UTAH DEPARTMENT OF TRANSPORTATION

SUBJECT: Standards Committee Meeting Minutes and Next Meeting

June 30, 2005

EN 1

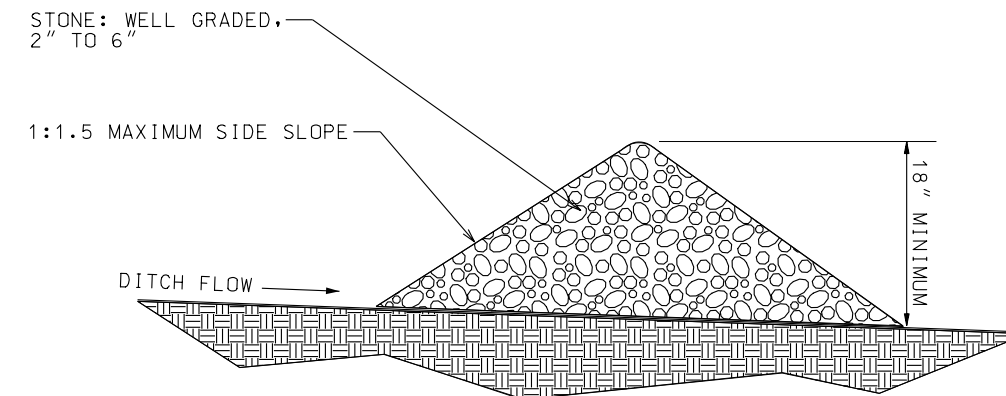
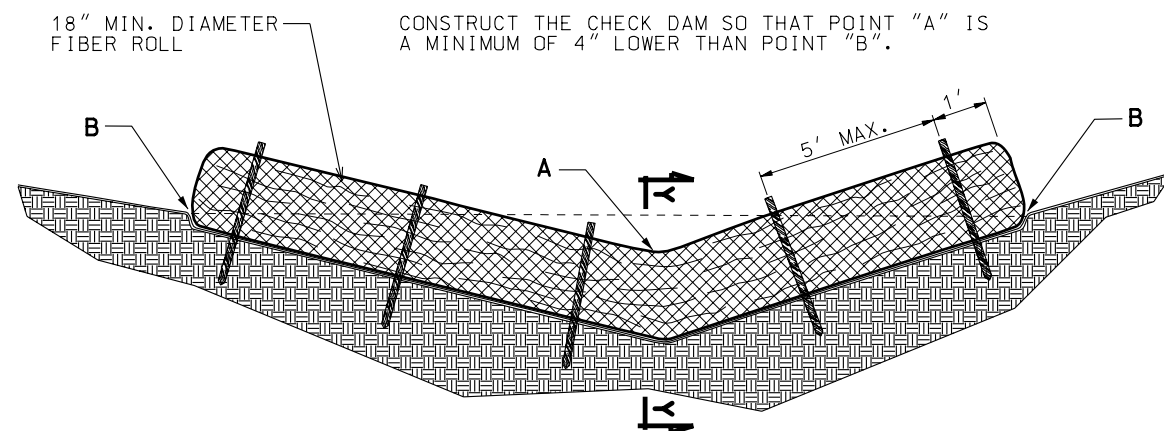
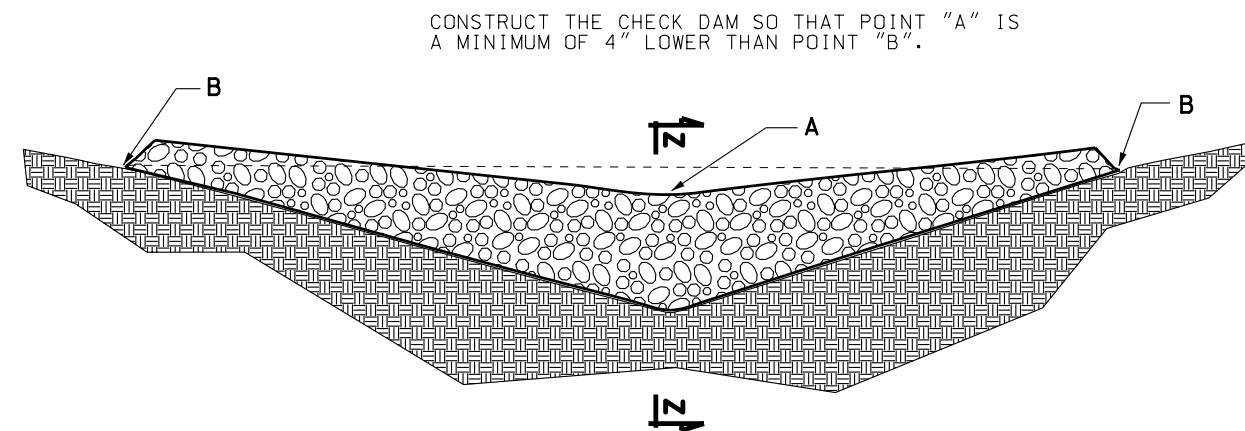
- Richard commented on the Maintenance issue related to Check Dams. He said he is bringing this up because of problems with previous standards relating to Check Dams. He went on to explain the problem and that rocks were washed into the culvert, requiring additional work by Maintenance to clean the area and open up the culvert. Richard said he wanted to make sure Terry did the correct calculations to make sure the system was designed correctly.

- Brent said Terry thought inadequate spacing between the Check Dams contributed to the problem. He thought these changes would take care of that problem. The change in the diameter of the rock to a larger rock will help with the problem as well.
